AMENDMENTS TO THE DRAWINGS:

REMARKS

Claims 1-15 and 22-35 are pending in the present application. Claims 16-21 were canceled; claims 1-12, 22-27, 30-32, 34 and 35 were amended. Reconsideration of the claims is respectfully requested.

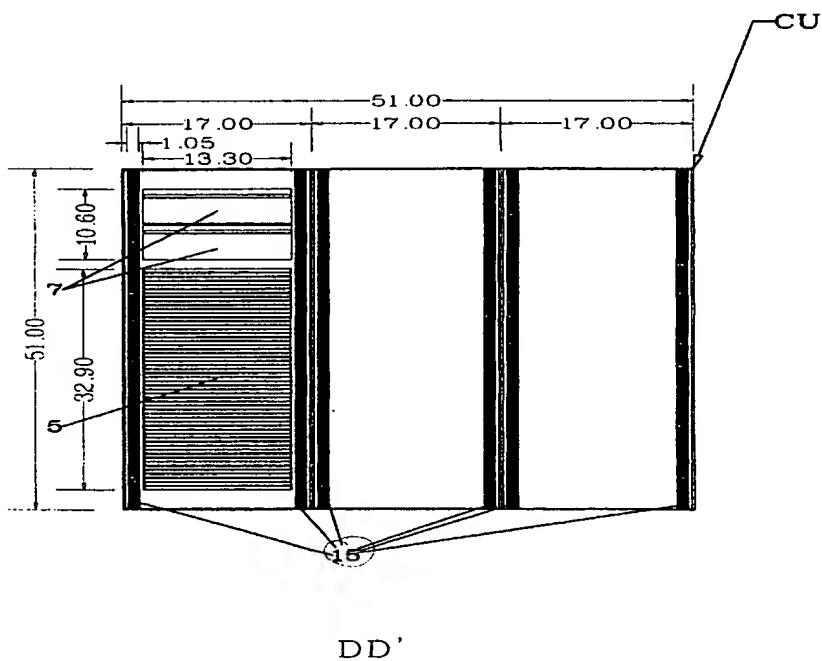
Additionally, claim 1 recites the feature of “module tracks, wherein the module tracks are substantially parallel rows of configurable instances of tracks attached to the housing on which the robotic hands travel.” *Toumbas* does not teach this feature. The Examiner points to element 15 in Figure 7 as teaching this feature. However, element 15 of Figure 7 is not the same as “module tracks, wherein the module tracks are substantially parallel rows of configurable instances of tracks attached to the housing on which the robotic hands travel,” as recited in claim one of the present invention. Instead, *Toumbas* teaches that element 15 is the “Z direction carrier (ZC) motion spur gears.” (*Toumbas*, col. 4, line 27). These are not configurable. They are built into the control unit, and neither the position of the ZC motion spur gears within the unit, nor the configuration of the ZC motion spur gears in the storage module can be changed, as illustrated by Figure 7 of *Toumbas* reproduced below for the convenience of the Examiner.

Furthermore, *Toumbas* does not teach, suggest, or give any incentive to make the needed changes to reach the presently claimed invention. *Toumbas* actually teaches away from the presently claimed invention because it teaches a very specific configuration for the gear tracks, wherein the gear tracks are in a fixed, unchangeable position within the storage module, as illustrated by figure 7, shown above. In contrast, the presently claimed

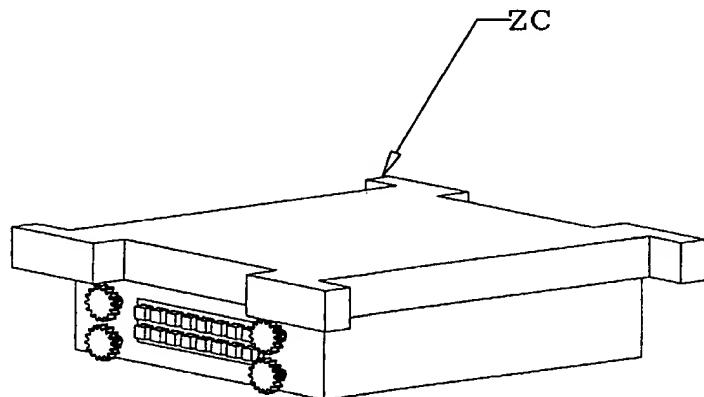
Figure 52 of *Toumbas* reproduced below for the convenience of the Examiner, shows the position of elements 49, the “gears to facilitate it’s movement through the DTC,” (*Toumbas*, col. 4, lines 64-65) on the ZC and provides further proof that the ZC motion spur gears are not configurable, as the gears are in one fixed place.

FIG. 1

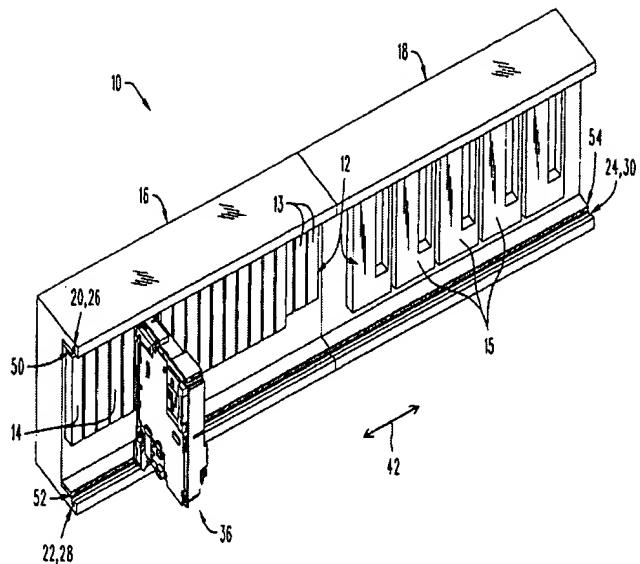
Looking at Figure 1 of *Luffel*, reproduced below for the convenience of the Examiner, which shows two storage modules connected to each other, it can be seen that due to the design of the storage module and the size of the cartridge access device, the gear racks 52 and 54 must be positioned where they are and there is no way to configure them any differently.

If the gear racks cannot change configurations, then they are not configurable. Therefore, it follows that *Luffel* does not teach the feature of “wherein the module tracks are substantially parallel rows of configurable instances of tracks attached to the housing of the storage module on which the robotic hands travel.” Thus, *Luffel* does not anticipate the present invention as recited in claim 22, because *Luffel* fails to teach each and every element of claim 22.
